Engineering Technologies Inc

### Pre-Bid Addendum #1

Partial Plan

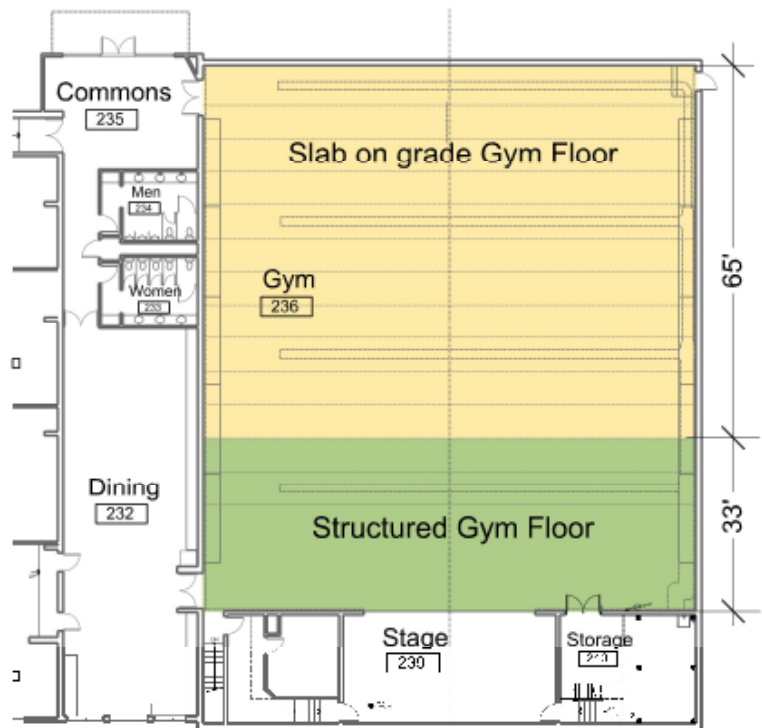
Questions about lift size allowed over the structured floor (where basement occurs below the gym floor at the east end, near the stage) and wood floor protection were raised. The Owner has used a scissor lift in the gym for lighting maintenance. Contractor may assume that a single scissor lift no larger than a typical 30" wide, 19' reach, weight up to 2,900 pounds may be used over the structured floor.

Multiple lifts may be used over the slab-on-grade gym floor.

Contractor shall take precautions to protect the existing wood floor from construction damage resulting from lifts or any other operation. Any damage that occurs shall be repaired and returned to the previous condition.
